COMMONWEALTH OF KENTUCKY
BEFORE THE PUBLIC SERVICE COMMISSION

THE ELECTRONIC APPLICATION OF)	
EAST KENTUCKY POWER COOPERATIVE,)	
INC. FOR 1) A CERTIFICATE OF PUBLIC)	CASE NO.
CONVENIENCE AND NECESSITY TO)	2024-00310
CONSTRUCT A NEW GENERATION)	
RESOURCE; 2) A SITE COMPATIBILITY)	
CERTIFICATE; AND 3) OTHER GENERAL RELIEF))

RESPONSES TO SIERRA CLUB’S THIRD INFORMATION REQUEST

DATED FEBRUARY 6, 2025

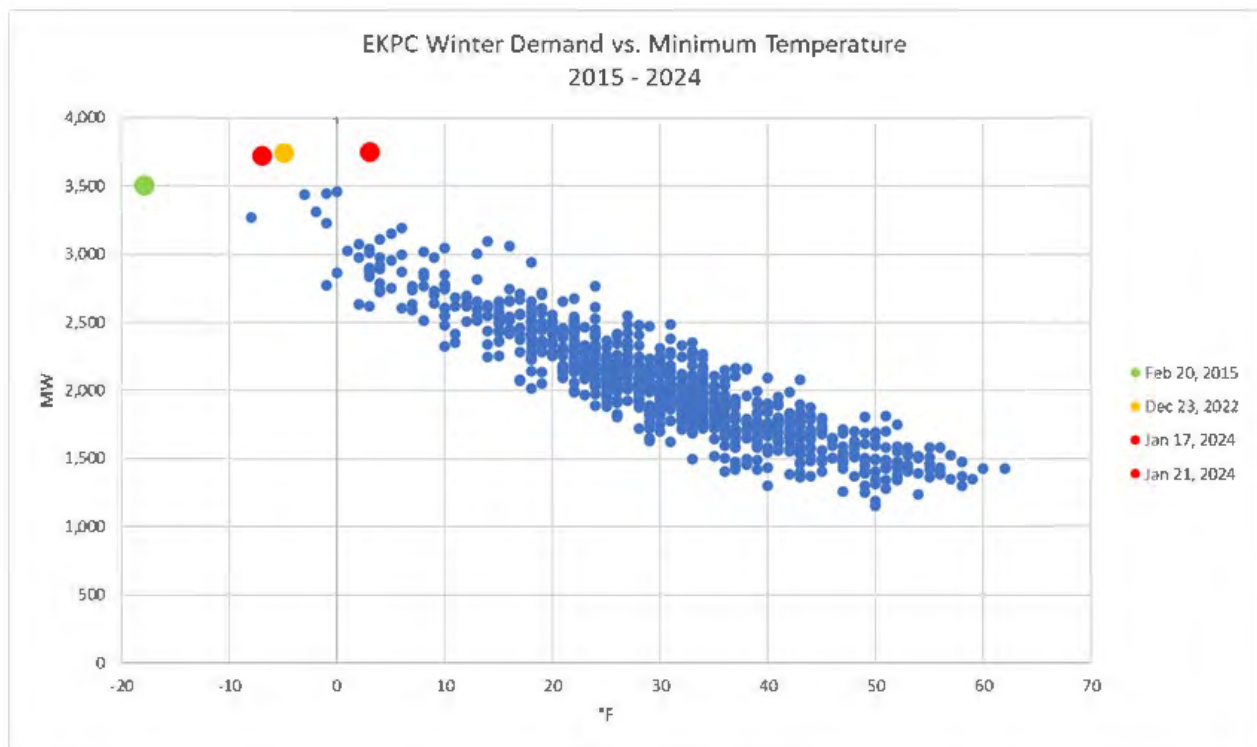
b. Please provide any analyses performed by EKPC or its members to understand the “saturation of the load within the system due to the cold weather.”

b. See graph below of EKPC’s historical daily peak load plotted against daily minimum temperature. Prior to Winter Storm Elliott, EKPC’s all-time peak was in February 2015 (green dot). EKPC’s peak loads during Winter Storm Elliott (orange dot) and Winter Storm Gerri (red dots) are well above previous peaks. It is notable that these peaks occurred at temperatures warmer than those during 2015. This illustrates the saturation of the load during the cold weather.
